Landscape Review Committee
Community Development Center, 231 NE 5th Street
September 19, 2018
12:00 PM

DATE: September 19, 2018
TO: McMinnville Landscape Review Committee
FROM: Jamie Fleckenstein, Associate Planner
SUBJECT: Agenda Item 4A: L 25-18

DATE: September 19, 2018
TO: McMinnville Landscape Review Committee
FROM: Jamie Fleckenstein, Associate Planner
SUBJECT: Agenda Item 4B: L 26-18

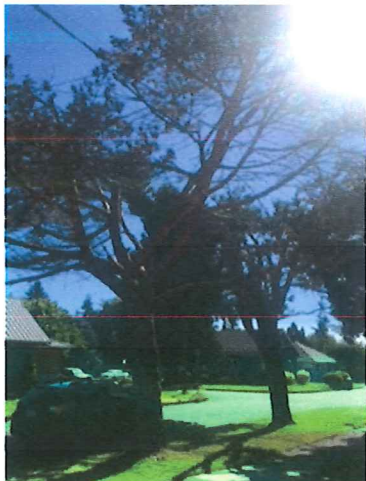
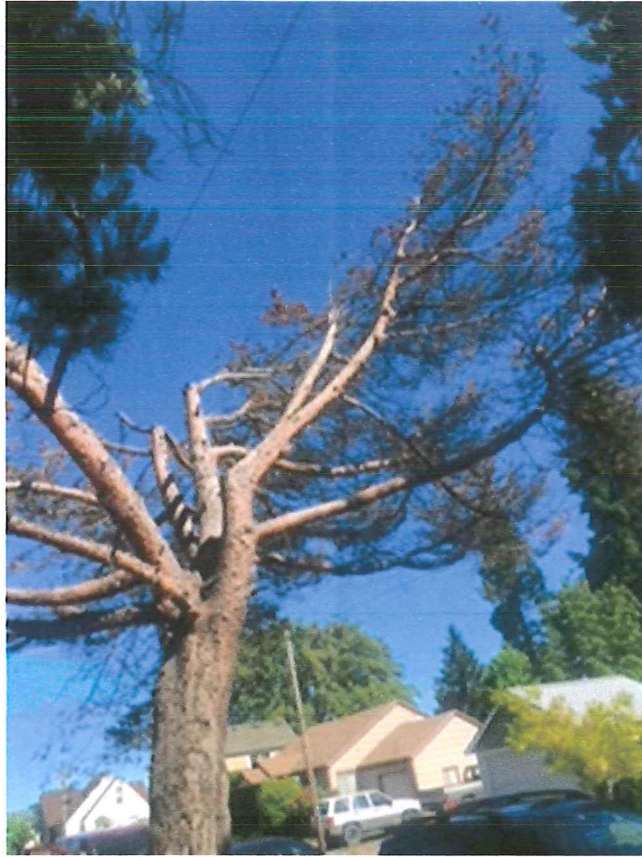
The tree in question seemed to be dead. The tree had 100% brown, dry needles and cones, no evidence of sapwood or new growth in the branches, and shows no sign of vigor. The adjacent street tree of the same species shows green foliage, live cones, sapwood in the new growth of branches, and normal vigor. The tree was previously heavily pruned for overhead power line clearance, and as a result the tree's previous growth was forced out. The tree had large branches that are at risk of failing, potentially causing damage to the overhead utilities and targets in the public right-of-way. Although no arborist report was submitted with the application, the evidence that the tree is dead is clear to a layman. The street tree removal request could be found to satisfy this criteria.

The applicant did not propose to replace the dead tree as part of the application. A condition of approval has been included to require that the tree to be removed shall be replaced with a small street tree from the McMinnville Street Tree List that is suitable for a location under overhead utility lines. The replacement tree shall be a variety of Flowering Cherry (*Prunus sargentii*) such as ‘Okame’, ‘Akebono’, ‘Accolade’, ‘Rosea’, or ‘Mt. Fuji’.

1206 NE 11th WAY LANDSCAPE PLAN

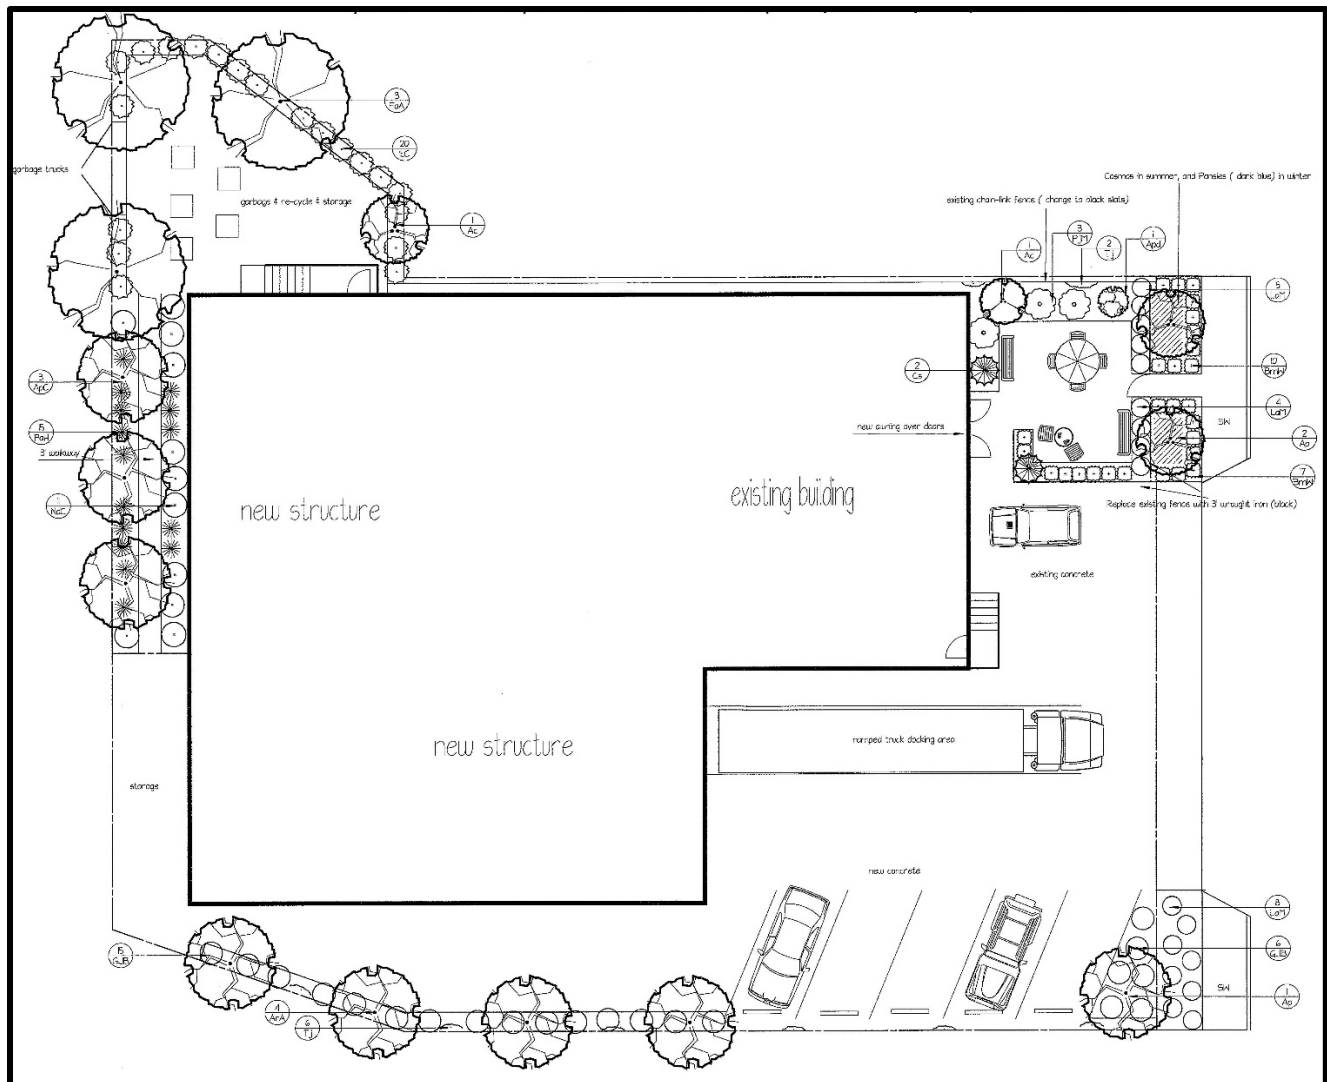
Through the Northeast Gateway Development Design Review, the applicant is requesting a waiver for the courtyard area from the zoning requirement that all landscaping between the front building line and the right-of-way be maintained at a height of three (3) feet or less. The waiver would allow the taller shrubs and trees along the NW property line to provide more buffering and screening from the adjacent use, the junk yard. Staff recommends a condition of approval that if the Northeast Gateway Development Design Review waiver for height of landscaping along the northwest property line is not granted, that the applicant shall provide a revised landscape plan for the courtyard showing landscaping that will be maintained at or below the three (3) foot maximum height to the Planning Department for staff approval.

Along the southeast property line, the proposed development includes the addition of five (5) new off-street parking spaces. Off-street parking is required to be screened by a continuous row of shrubs between three (3) and four (4) in height. In the planter next to the sidewalk in the public-right-of-way, a mass of Munstead Lavender is proposed. In the planting area within the site adjacent to the parking, one (1) Japanese Maple is proposed, with a mass of *Geranium x 'Johnson's Blue'* (Johnson's Blue Cranebill) below. Johnson's Blue Geranium is an herbaceous flowering perennial growing to a height of 18". To meet the NE Gateway District requirement that landscaping between the front building line and the right-of-way be 3' height or less, staff recommends a condition of approval that the *Acer palmatum* (Japanese Maple) in the planting area southeast of the new off-street parking be moved to the planting area in the adjacent right-of-way. To meet the NE Gateway District requirement that and that the parking be screened by a hedge between 3' and 4' height, staff recommends a condition of approval that the evergreen shrub *Buxus microphylla* 'Winter Gem' (Winter Gem Boxwood) be substituted for the six (6) *Geranium x 'Johnson's Blue'* (Johnson's Blue Cranebill) between the new parking and the 11th Way right-of-way, and maintained at a height of three (3').

Between the proposed off-street parking and the southwest property corner, an approximately 30" to 36" wide planter is proposed with four (4) *Acer rubrum* 'Autumn Spire' (Autumn Spire Red Maple) planted at approximately 20' on center, and Johnson's Blue Cranesbill between them. Star Jasmine is proposed to be planted at approximately 20' on center for the length of the fence. Given that the minimum recommended width of planting strip for red maples in the public right-of-way is five (5) feet, staff recommends a condition of approval that the width of the planter along the southeast property line be increased to five (5) feet.

Applause White Ash) and one (1) Vine Maple. Autumn Applause White Ash grows to 40' tall and 25' wide. Between the trees are groupings of *Ilex crenata* 'Compacta' (Compact Japanese Holly), an evergreen shrub growing to 6'x6'. Staff believes the 2' wide planting area is not appropriate to accommodate the proposed trees and Compact Japanese Holly. Staff recommends a condition of approval that the width of the planter along the perimeter of the garbage/recycle/storage area in the northwest corner of the site be increased to a minimum of (4) feet, to match the adjacent planter with trees.

There are, however, trees proposed for planting in the public right-of-way, in the planter between the sidewalk and subject site. The proposed trees are three (3) *Acer palmatum* (Japanese Maple). The proposed Japanese Maple is the standard species that grows to over 20' in height. As such, it is a

1. That the applicant shall install landscaping as shown on the landscape plan dated August, 2018.
2. That if the Northeast Gateway Development Design Review waiver for height of landscaping along the northwest property line is not granted, that the applicant shall provide a revised landscape plan for the courtyard showing landscaping that will be maintained at or below the three (3) foot maximum height to the Planning Department for staff approval.

3. That the *Acer palmatum* (Japanese Maple) in the planting area southeast of the new off-street parking be moved to the planting area in the adjacent right-of-way.

5. That the width of the planter along the southeast property line be increased to five (5) feet.
6. That the width of the planter along the perimeter of the garbage/recycle/storage area in the northwest corner of the site be increased to a minimum of (4) feet.
